VIRGINIA ELECTRIC AND POWER COMPANY
SURRY POWER STATION UNITS 1 AND 2
INSERVICE TESTING PROGRAM
REQUEST FOR ADDITIONAL INFORMATION
ACCUMULATOR CHECK VALVE TESTING

ADDITIONAL INFORMATION TO SUPPORT RELIEF REQUEST V-26

FIGURE 1
 "B" ACCUMULATOR
 DISCHARGE PIPING

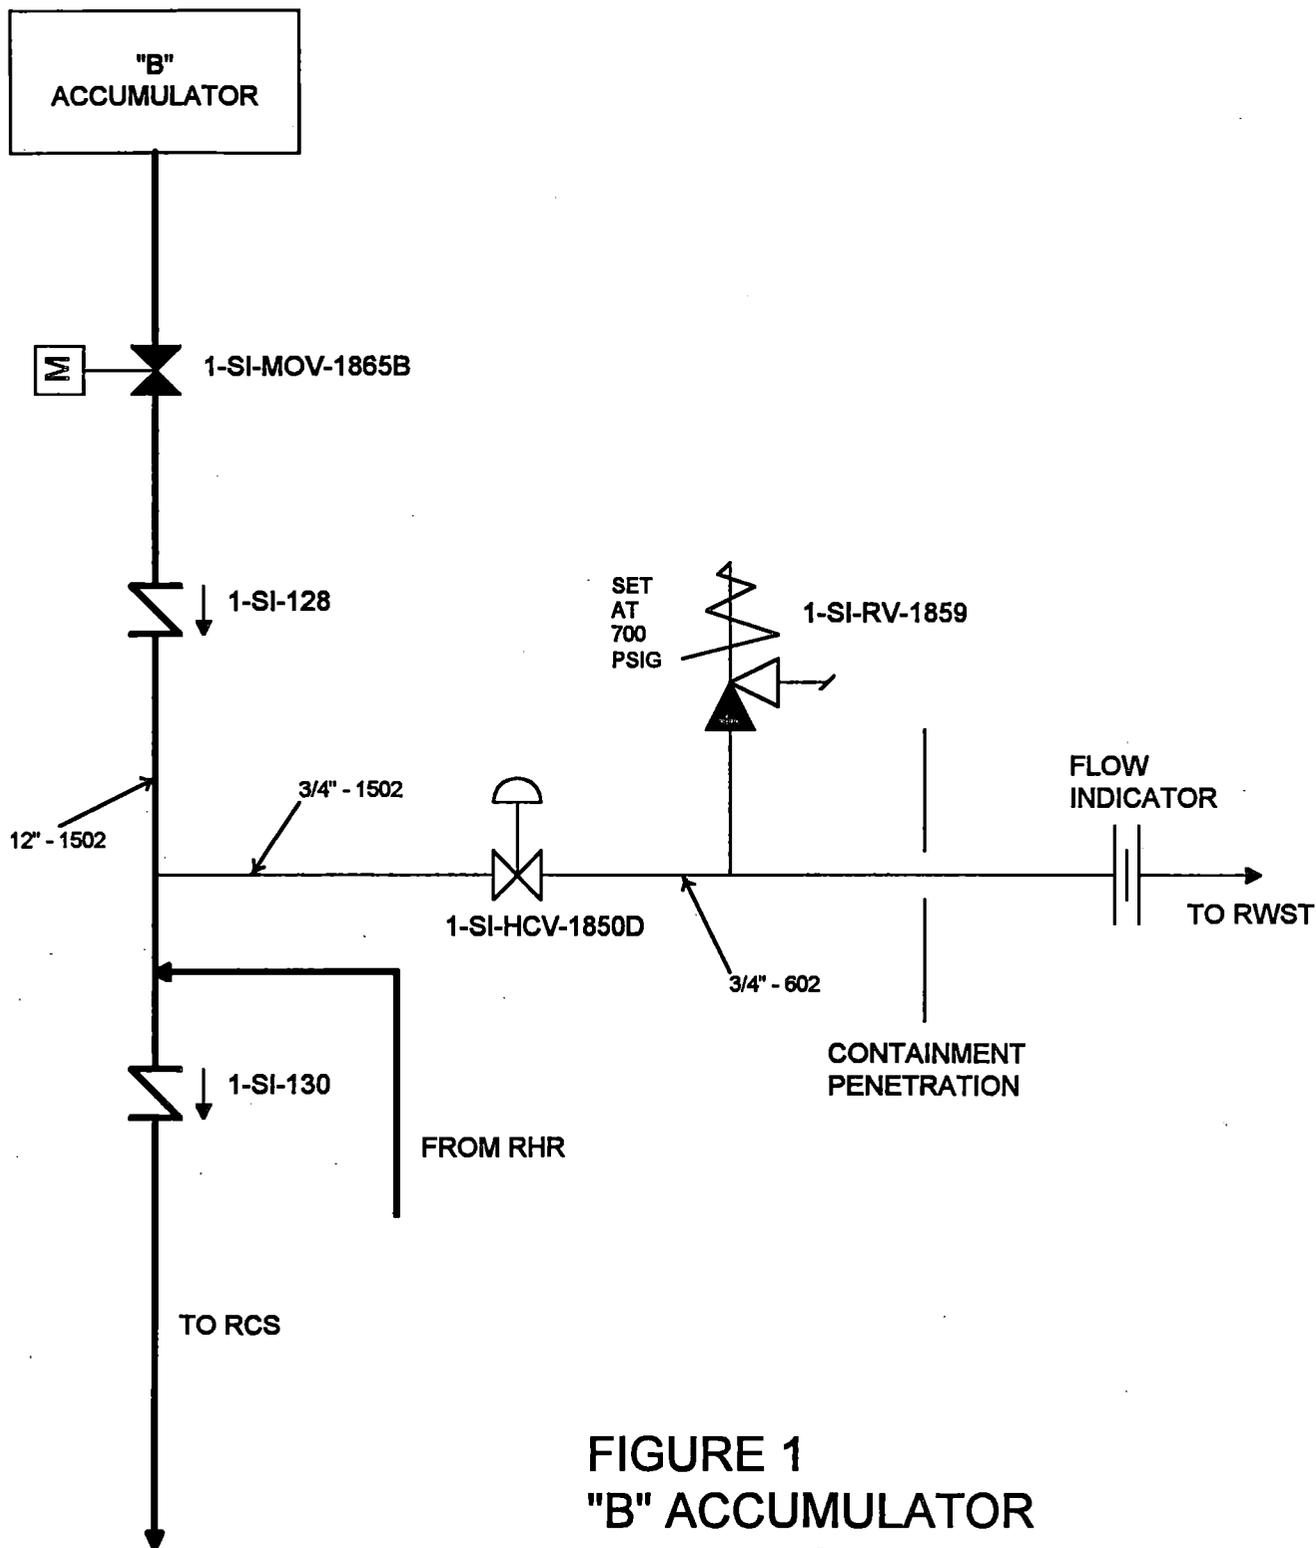
Testing experience has shown that a water hammer can be produced when testing the downstream valve. The back seat tests are performed when the plant is in the heatup phase following a cold shutdown or refueling outage. Using Figure 1 as a reference, the test configuration for the "B" accumulator discharge check valve consists of closing the 12" motor operated isolation valve 1-SI-MOV-1865B and opening the 3/4" valve 1-SI-HCV-1850D. With the RCS at an elevated pressure, a flow path from the check valve to the refueling water storage tank (RWST) is created to measure any back leakage through the check valve (1-SI-130). Flow is measured using the flow indicator 1-SI-FI-1942.

A Root Cause Evaluation of the event for the "B" accumulator revealed that the water in the 12" piping between check valve 1-SI-130 and isolation valve 1-SI-MOV-1865B was at an elevated temperature and pressure due to the RHR system configuration. Note in Figure 1 that the RHR system discharges to the RCS via the safety injection

line between the check valves. The "C" accumulator has the same configuration. The water began flashing to steam when valve 1-SI-HCV-1850D was opened creating an atmospheric vent path, which forced water out of the 12" line into the RWST. This process continued until the flow indication at 1-SI-FI-1942 settled to zero. By the time 1-SI-HCV-1850D was closed, a substantial steam bubble was created in the 12" line. Therefore, when the relatively cold accumulator water (<100°F) was introduced to the volume with the opening of 1-SI-MOV-1865B, the steam bubble collapsed creating a hydraulic transient. The same series of events occurred during the testing of 1-SI-147 on the "C" accumulator but a more significant hydraulic transient occurred. A walkdown of the system revealed no damage to the discharge piping or support structures.

Various ways to eliminate the water hammer were investigated. After closing 1-SI-HCV-1850D, 1-SI-MOV-1865B could be opened slowly to gradually fill the volume. However, 1-SI-MOV-1865B is a 12" gate valve with very poor low flow control. A small change in stem location translates to a large change in flow area. 1-SI-MOV-1865B cannot be relied on to preclude water hammer events.

The piping could be allowed to cool after RHR operation. However, this cooldown period would delay startup. Furthermore, there is presently no installed temperature instrumentation to determine when the piping is sufficiently cool that it would be safe to open the MOV.

The piping downstream of the flow indicator could be isolated and the acceptance criteria be based on pressure increase. This method is used at North Anna. However, Surry has a relief valve on the 3/4" line that opens at 700 psig. This relief valve can lift before the check valve is properly seated. North Anna does not have a similar relief valve in their piping configuration.
